Referee Comment 1. I was a little confused by the use of the terms 'low water' and 'high water' for discharge conditions. Usually they are used to indicate tidal elevation. I would therefore suggest replacing these words by 'low discharge' and 'high discharge' or 'low fresh water discharge' and 'high fresh water discharge'.

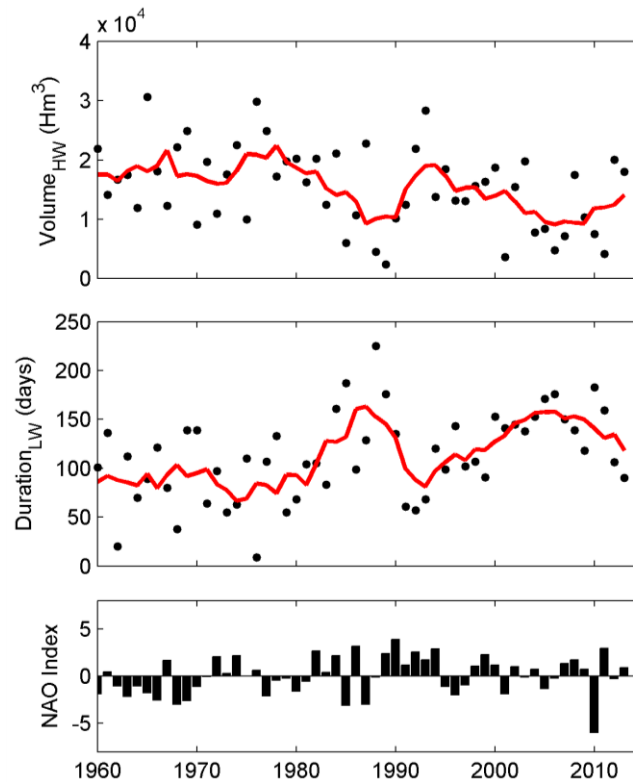
Referee Comment 2. The abstract starts with 'climate change and human activities'. I was immediately focused on these terms, but only very limited information was presented in the ms on these subjects. What do you mean by climate change? Is it global warming and its effect on e.g. precipitation or do you mean climate variability, such as the NAO?

Regarding the latter, the changes in e.g. duration of LW (low discharge) in Fig 15 correspond at a quick view (see http://www.cpc.ncep.noaa.gov/data/teledoc/nao_ts.shtml) with the variations in NAO index. The increase of LW duration in the 80's is correlated partly with a period (79/80-94/95) of positive NAO index. What is the effect of human impact (water usage for irrigation)? Do you have data that show the amount used for this purpose?

Yes, we begin the abstract with "climate change and human activities" to indicate the context of the article, however this is not the specific objective of the work. We know that the annual mean discharge of the Garonne-Gironde system has decreased over the last decades (see section 4.1 1st paragraph). There are already dedicated studies that confirm the influence of both human impact and climate variability in freshwater variations, like those of Mazzega et al. (2014) and Hendrickx and Sauquet (2013), both cited in the article.

Such context is expected to affect natural distribution of estuarine SPM, as explained in the introduction. However we do not have historical data in the tidal Garonne River. Therefore, the objective of the article is to detail turbidity dynamics in the upper reaches of the Gironde estuary in relation with the present-day hydrological conditions, based on a high-frequency turbidity records that covers only the last 10 years. However we are convinced that figure 13 and 14 clearly demonstrate the decisive control of fluvial discharge (duration-low water; winter-volume) on TMZ occurrence in the tidal Garonne. The figure 15 is presented to show that these two indicators have already changed over the period 1959-2014.

We agree with the observation that the changes in duration of low discharge (Fig. 15) present some similarities with the NAO index. In fact, we have envisioned a first version of the figure 15 including the NAO index (see below). However we assessed that the article could be considered stodgy with the presentation of 10-yr high frequency turbidity records, to avoid an additional and more speculative discussion on long-term impact in the absence of detailed data on water abstraction on the same time period (1959-2014). If requested by the reviewer, we may replace the figure 15 to include NAO index.

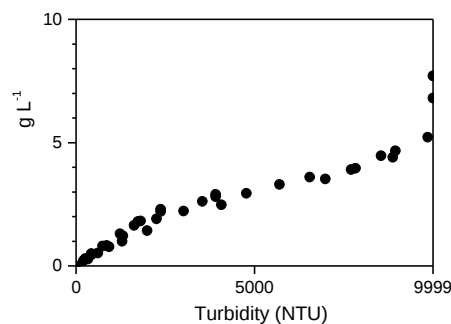
Referee Comment 4. I was not completely convinced by the definition of TMZ that you use, ie NTU>1000. A TMZ in an estuary can be present even if the overall turbidity is lower than this value as it depends on the turbidity more upstream and downstream of it. The occurrence of TMZ in estuaries has been discussed a lot in literature, but I don't think that a certain turbidity value was

proposed in order to have have a TMZ. You refer to 'old' papers from Allen et al (1977) and Allen & Castaing (1981) where they have used a threshold for turbidity in a TMZ. What is the scientific basis of using such a threshold?

Indeed in any estuary, a TMZ is defined as a zone where turbidity is higher than in upstream and downstream waters. However, for the Gironde estuary, there are pioneer works of Allen and Castaing that define the threshold of TMZ at 1 g L^{-1} based on numerous field determinations of suspended load distributions.

As our work is in the same fluvio-estuarine system, we use the same TMZ definition (in fact changing the threshold should have been justified), i.e. the TMZ is present when particle load values exceed 1 g L^{-1} . The critical point is in fact the turbidity – SPM relationship, as the automated stations measure turbidity and not particle load. Ongoing works on $[\text{SSC}, \text{g L}^{-1}] = f(\text{Turbidity, NTU})$ curves based on particles collected at Bordeaux and Pauillac show that 1000 and 9999 NTU correspond to about 1 and 5-6 g L^{-1} respectively (Schmidt, personal data, see figure). This justifies the use of 1000 NTU as the threshold of TMZ occurrence.

However this work could serve also to test the historical threshold. When the TMZ is installed at one of the four MAGEST station, we observe that the minimum value of tidally-averaged turbidity is always equal or higher to 1000 NTU, whatever the tidal range. This observation thus reinforces previous works. Figure 3 will be enlarged in the revised version and a horizontal line at 1000 NTU will be added in the figures 3C/D/E/F to better highlight this threshold.
